XRAY XB3TQ

SUPPLEMENTARY INSTRUCTIONS

To achieve more downtravel of the front suspension, please follow this handy tip to easily modify the chassis.

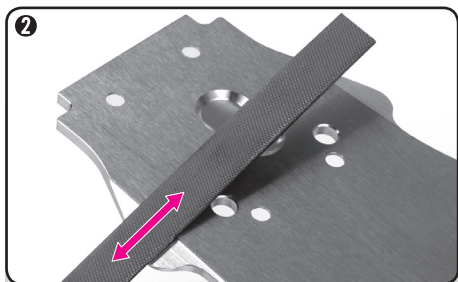
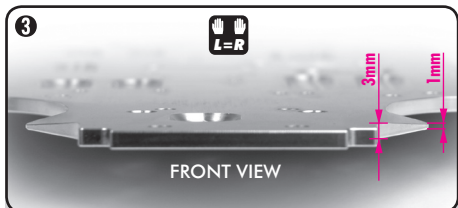
This is standard out of the box chassis. The highlighted area shows where the chassis needs to be slightly filed.

Using a file, slightly file the highlighted area under an angle on both left & right sides from the top of the chassis.

The edges of your finished chassis should look like in the shown picture.
